INTERNATIONAL STANDARD

AMENDMENT 1

Semiconductor devices – Discrete devices – Part 8: Field-effect transistors

Figure 10 – Basic circuit for the testing of peak reverse drain current of MOSFETs

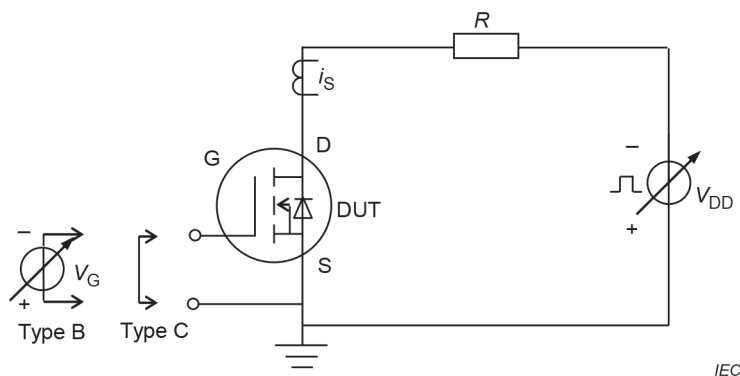
Replace the existing Figure 10 with the following new Figure 10:

Replace, under "Specified conditions", the existing fourth bullet with the following new bulleted point:

- Peak reverse drain current I_{SM}

Figure 34 – Current waveform through MOSFET (Method 1)

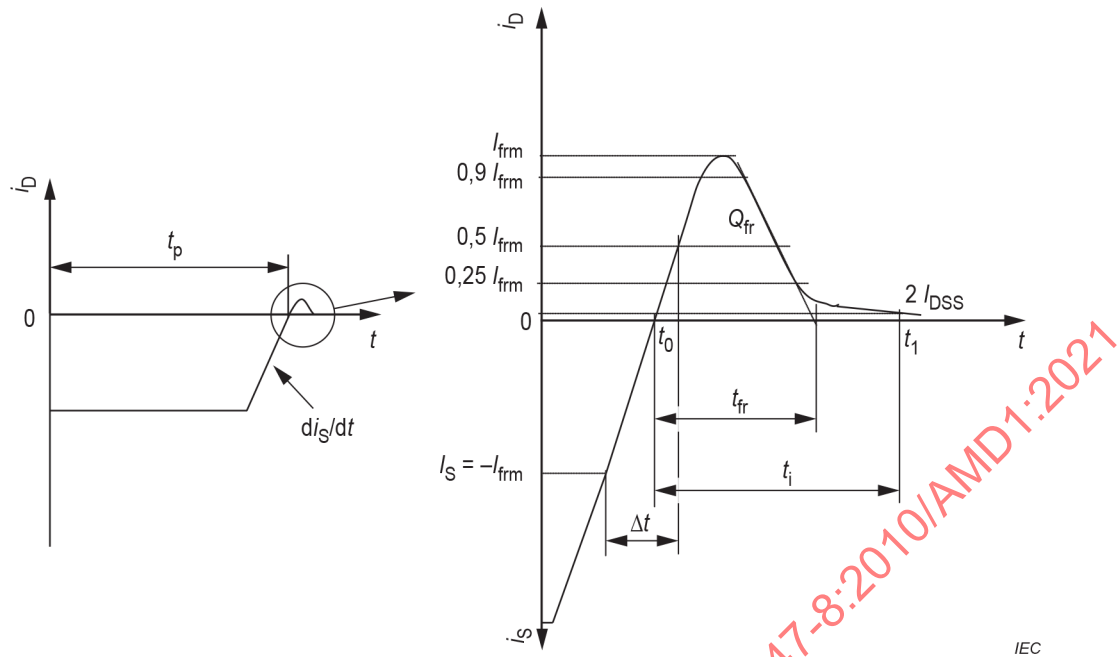
Replace the existing Figure 34 with the following new Figure 34:
